Sheet: / File: SAM21.sch		
Title:		
Size: A4	Date:	**Rev:**
KiCad E.D.A. kicad (5.1.2)-1		Id: 1/5

Sheet: /XBee_Sockets/
File: XBee_Sockets.sch

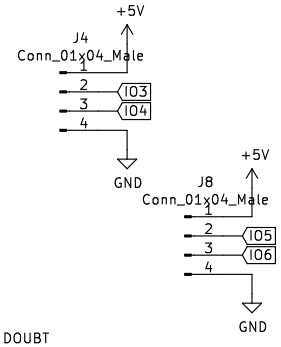
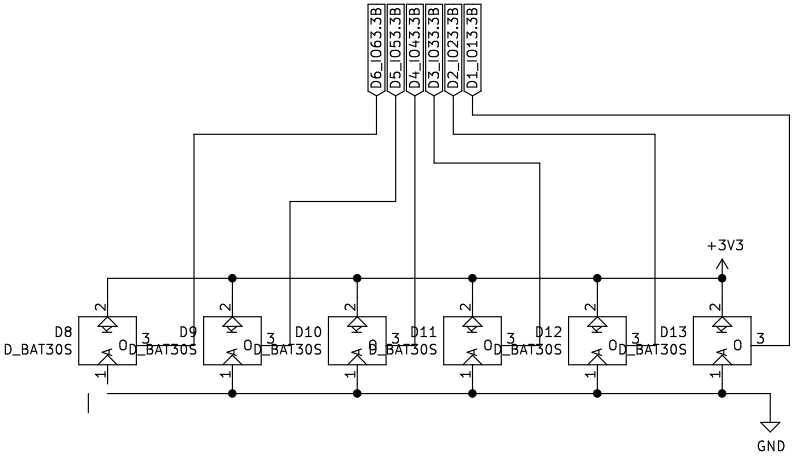
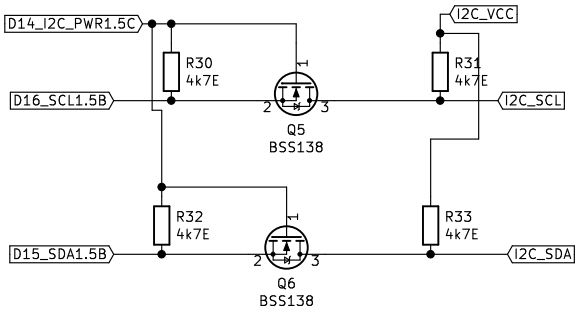
DOUBT
1. Should the IO1 and IO2 be exposed via headers (Since they are the reset pins for XBEE)

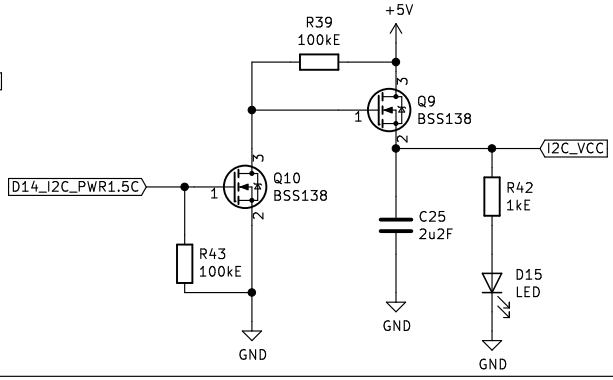
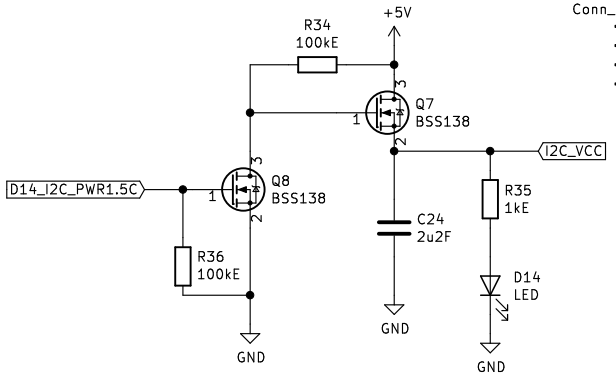
NOTE:
1. If this protection circuit can be removed BOM can be reduced
